Change Order

PROJECT *(Name and address)*:
East Middle School-Classroom Addition
130 Merlin's Maze
Biscoe, NC 27209

CHANGE ORDER NUMBER: 002
DATE: 08/25/2017
ARCHITECT'S PROJECT NUMBER: 1548
CONTRACT DATE: 04/05/2017
CONTRACT FOR: General Construction

CHANGE ORDER NUMBER: 003
DATE: 08/29/17

East Middle School
120 Mesling Maze

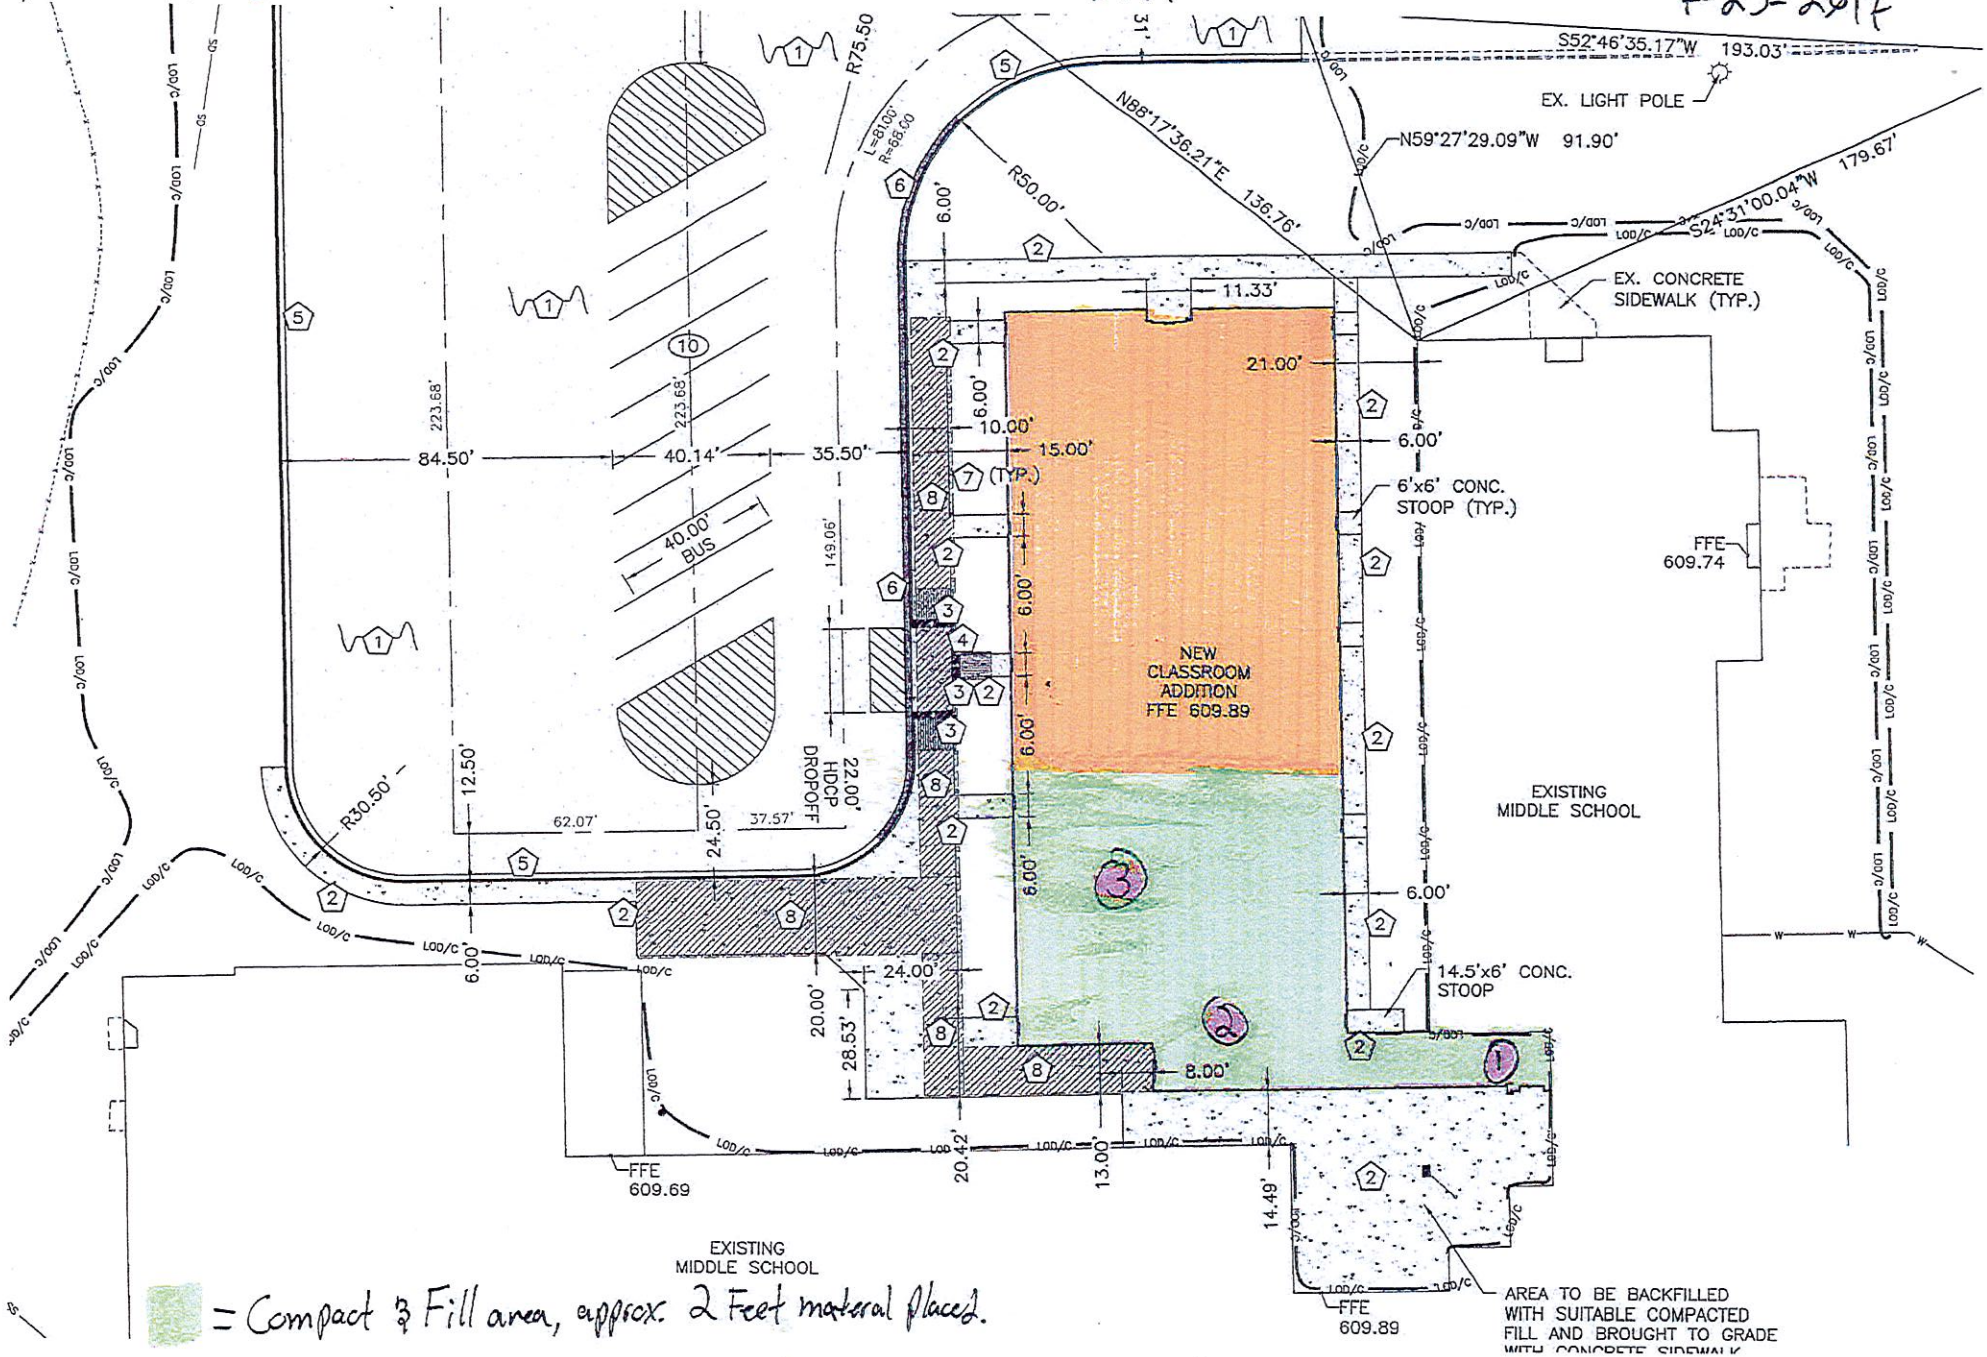
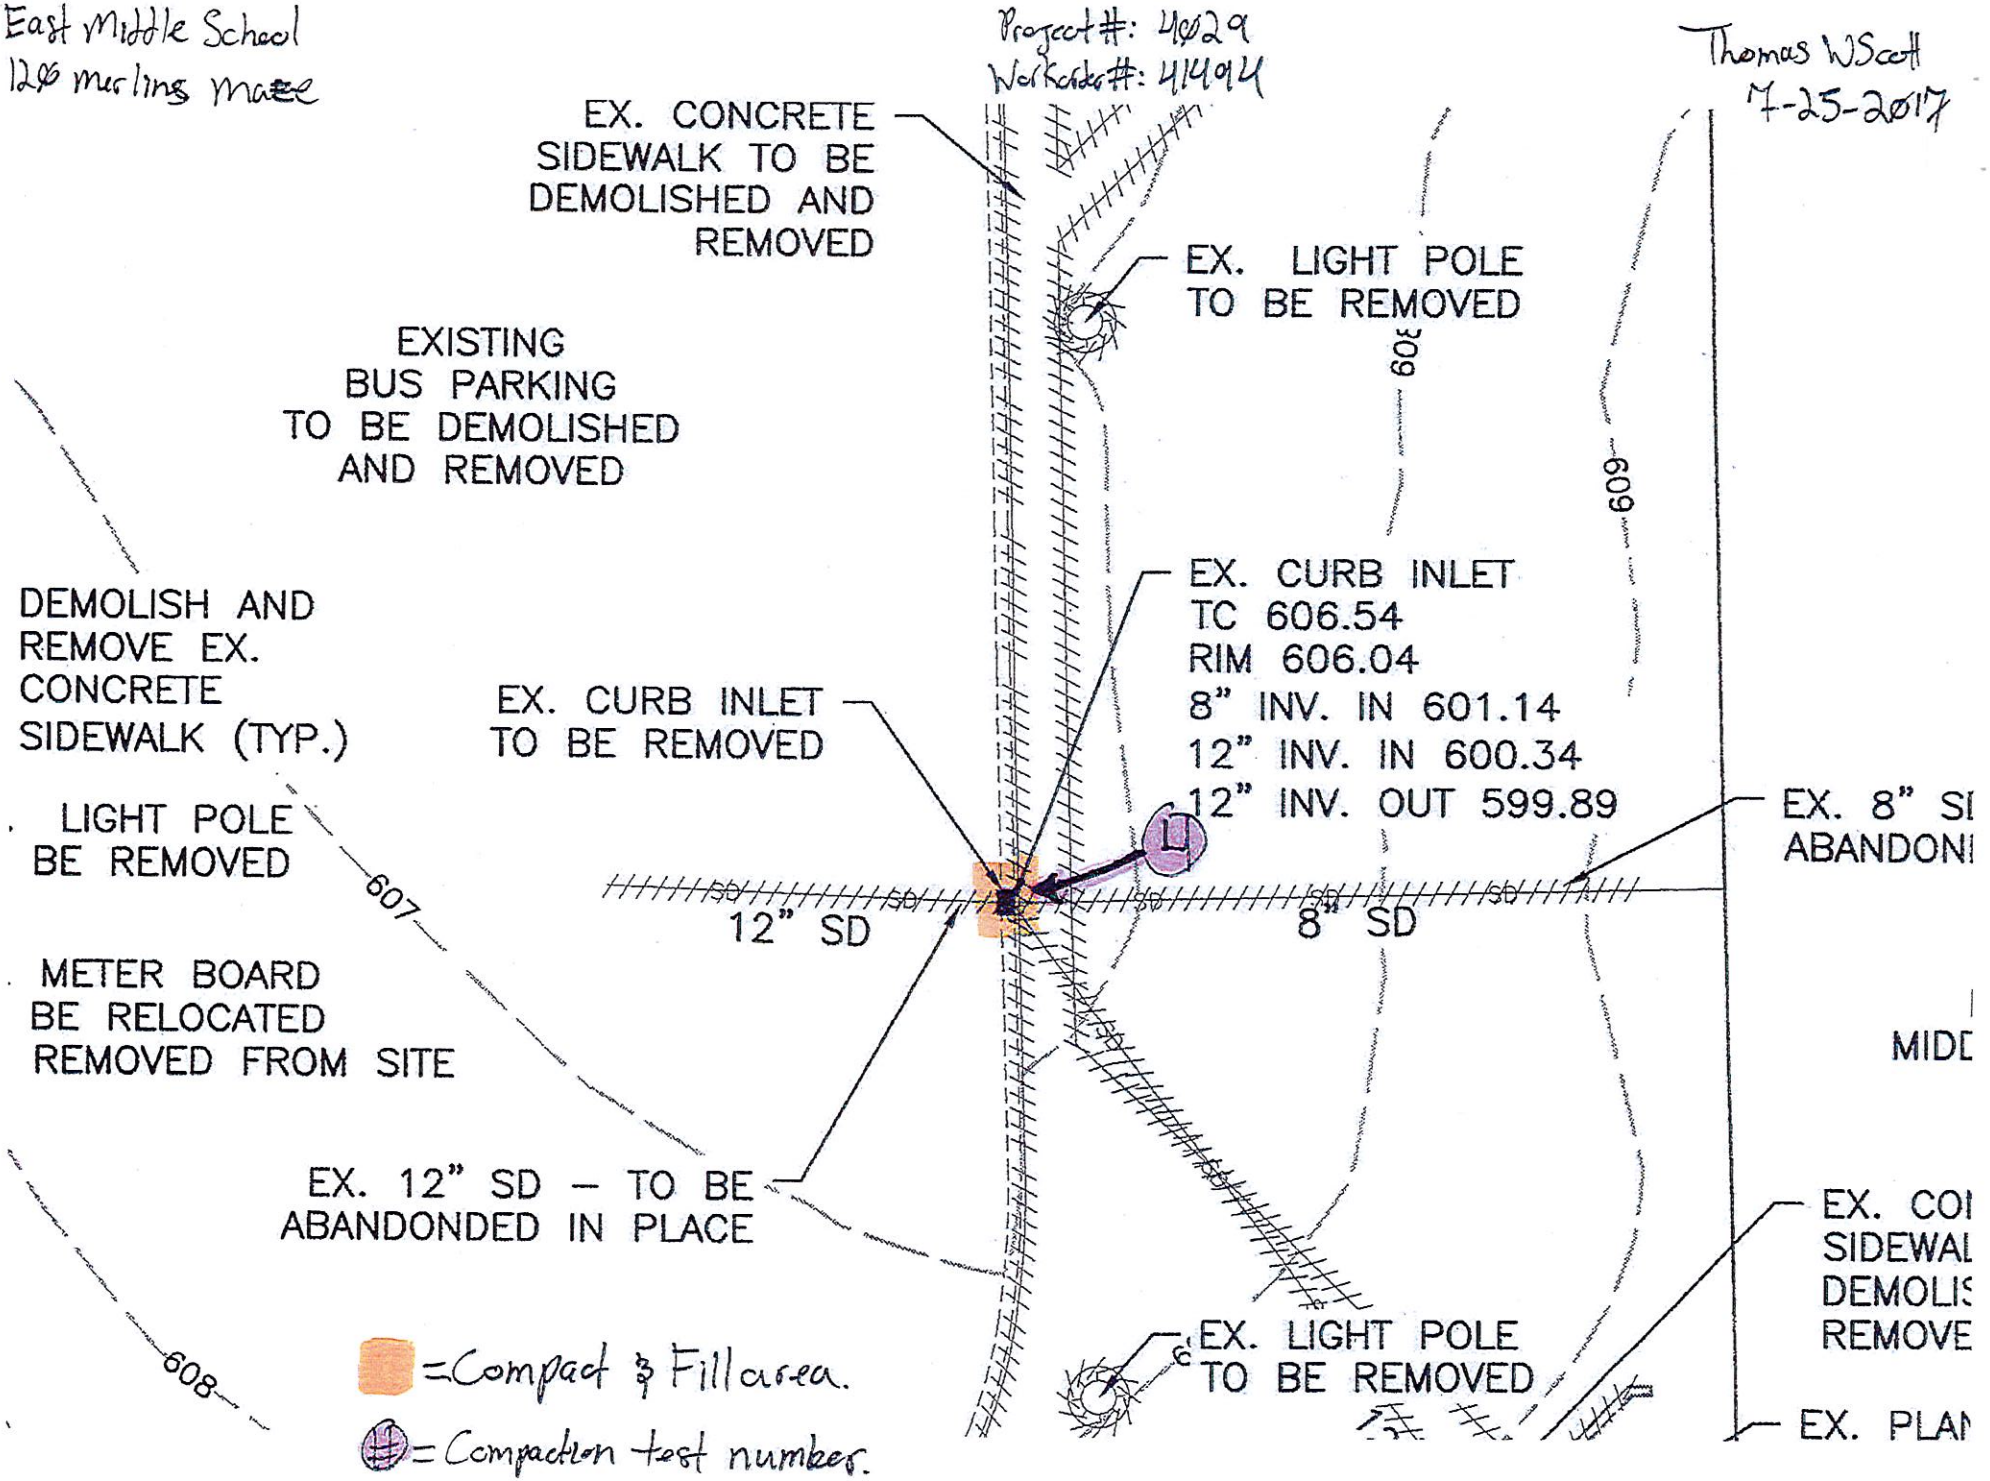
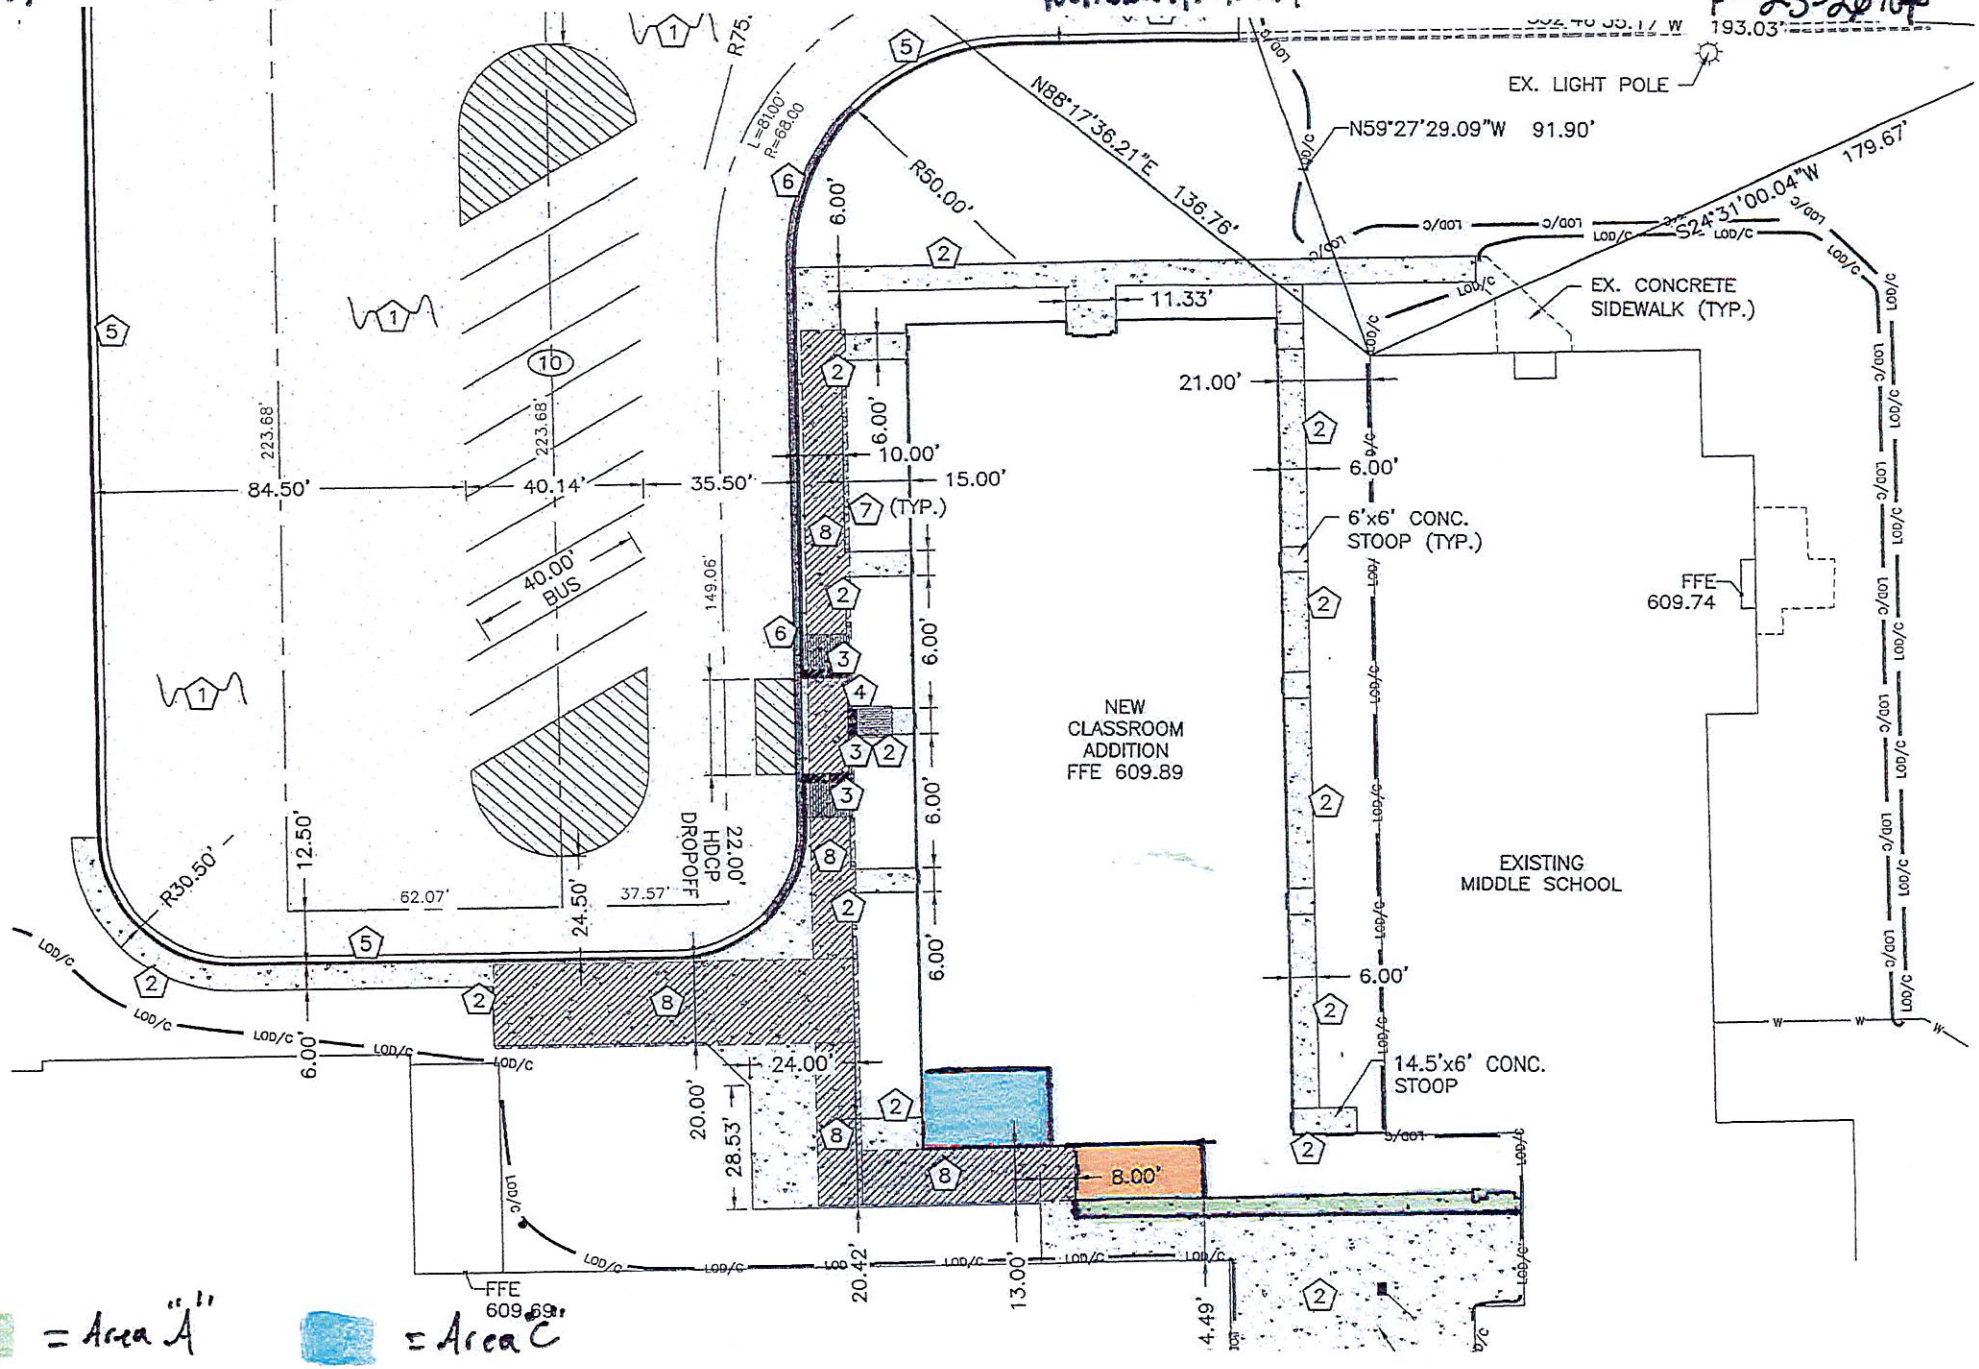
Upon excavation fat clays and silty clays were found. ECS recommendation remove unsuitable fill in building pad.

Soils quantifications for building pad area as follows; Area "A" 88.5' x 2.5' x 2' = 16.38 cubic yards, Area "B" 23' x 14' x 4' = 45.70 cubic yards. Area "C" 65 x 14' x 2.8' = 94.37 cubic yards

2: The placement and compaction of soils for void left from removal of existing curb inlet and for building pad. Please see the attached sketch for details on the location.

East Middle School
12th Merlins Maze

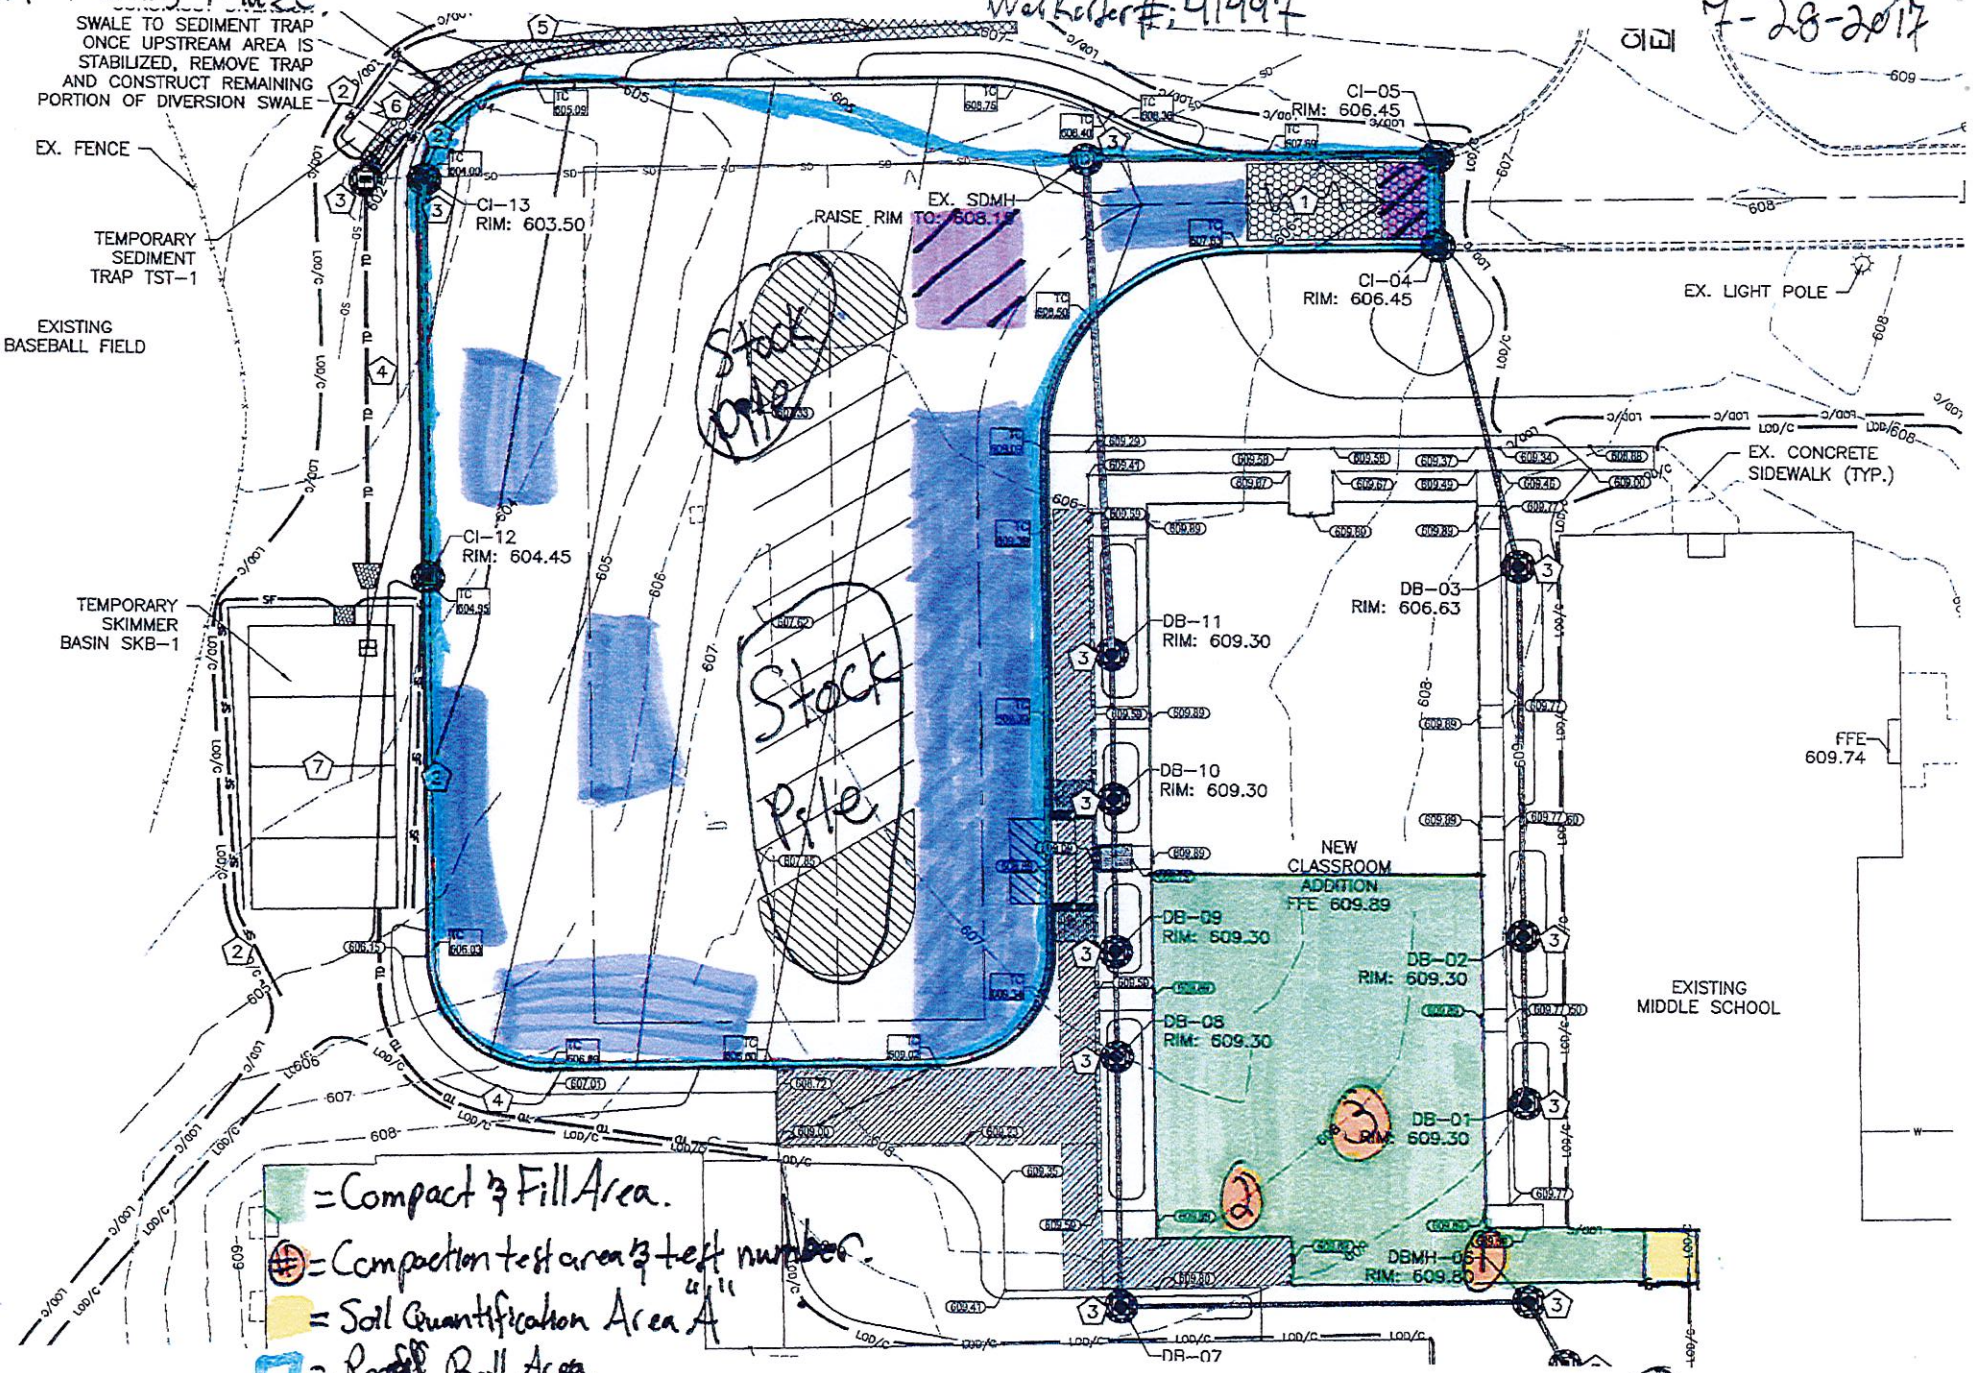
Visible signs of minor and major pumping and rutting were observed in areas indicated on sketch. ECS recommendations are to undercut parking lot/ bus RW approximately 1 foot below finished grade and back fill with suitable structural fill. Note, some areas are below subgrade

The removal of existing sidewalks/ concrete took place. Upon excavation fat clays were found below removed concrete. ECS recommendation was to over excavate approximately 3' from removal depth and 3'' 8"" from finished floor.

Soils quantifications for structural hallway are approximately = Area "A" 16' x 10' x 3' = 17.77 cubic yards.
